## **COMMITTEE OF THE WHOLE FEBRUARY 19, 2007**

### **SITE DEVELOPMENT FILE DA.06.076** **YORK CATHOLIC DISTRICT SCHOOL BOARD**

## Site Plan

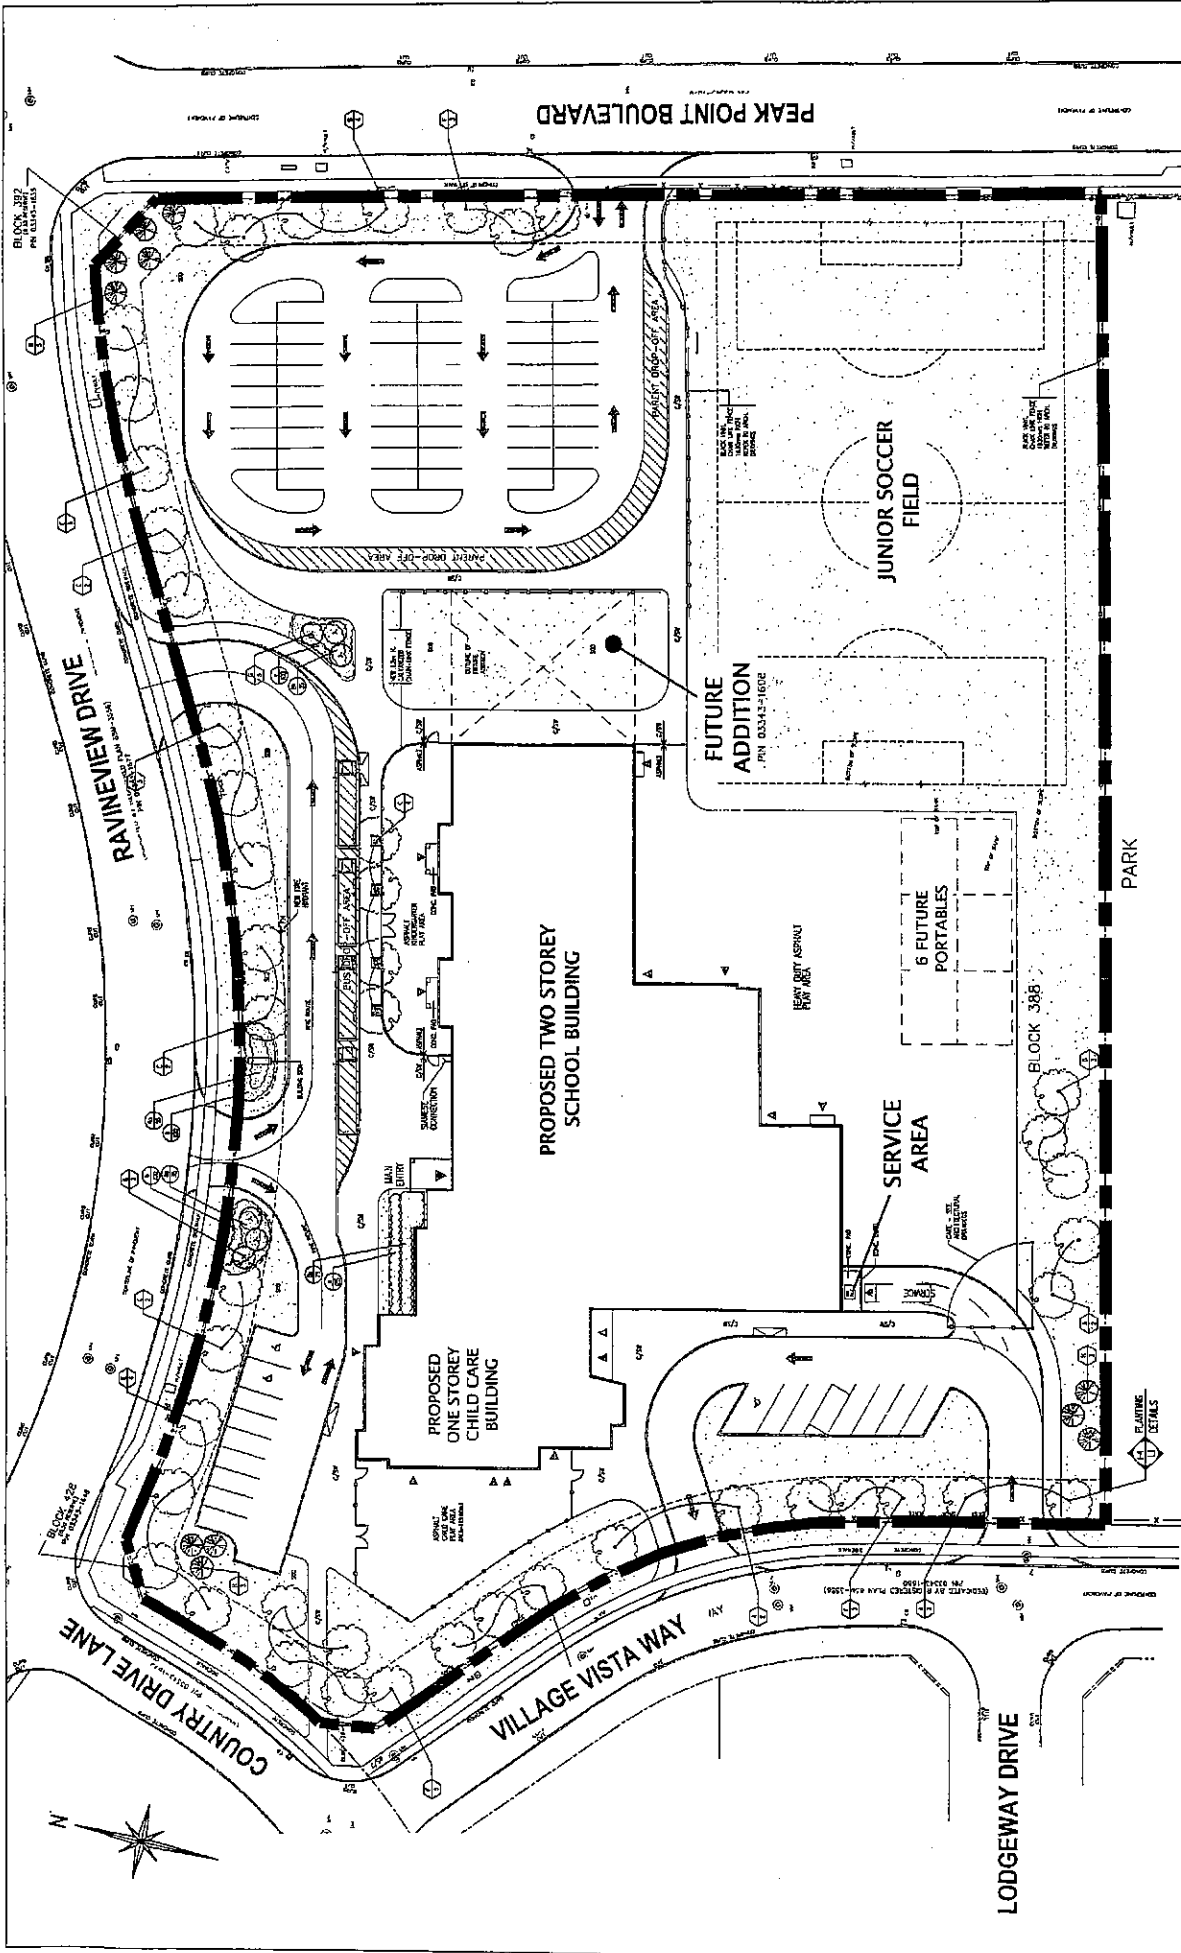
The proposed site plan is shown on Attachment #2. The proposed elementary school is located in the northwest portion of the site, and is two-storeys in height with a gross floor area of 5,665 m<sup>2</sup>. The school includes 25 classrooms, a gym, a library and an attached one-storey day nursery with 3 playrooms. The proposed school site includes a junior soccer field situated north of a future public park. The main entrance of the school fronts onto Ravineview Drive. A future addition is illustrated on the east side of the school, located between the proposed school and the main parking area. A future Site Development Application is to be required to facilitate the proposed addition, prior to its construction. Six future portables are proposed to be located between the school and the park to the south.

There is a one-way driveway in front of the school with an in/out-only access on Ravineview Drive to be used primarily by school buses. The drop-off area for parent use is located to the east of the school and accessed through the main parking area from Peak Point Boulevard. The garbage pick-up area is located at the southwest corner of the building and is accessed from Village Vista Way. An eight car parking lot is also located adjacent to the service area.

Vehicular access to the site is provided along each of the three abutting streets as shown on Attachment #2. The driveway on Ravineview Drive permits access to and from the school intended primarily for bus use. This driveway also provides access to a 9 car parking area at the northwest portion of the site. Access to the main parking area and parent drop-off area located east of the school is provided via a separate driveway from Peak Point Boulevard. The driveway from Village Vista Way provides access to the service area and an 8 car parking area located in the southwest portion of the site.

There are 68 parking spaces provided in three parking areas on the site. There is one primary parking area located in the easterly portion of the property with access to Peak Point Boulevard. There are two smaller parking lots in the westerly and northerly portions of the property with access from Village Vista Way and Ravineview Drive, respectively.

- a) that prior to the issuance of a building permit:
    - i) the final site plan, landscape plan, and building elevations shall be approved to the satisfaction of the Development Planning Department;

- ii) the final site grading and servicing plan, storm water management report, access, parking and on-site circulation be approved to the satisfaction of the Engineering Department;

The final site plan shall be approved to the satisfaction of the Development Planning Department.
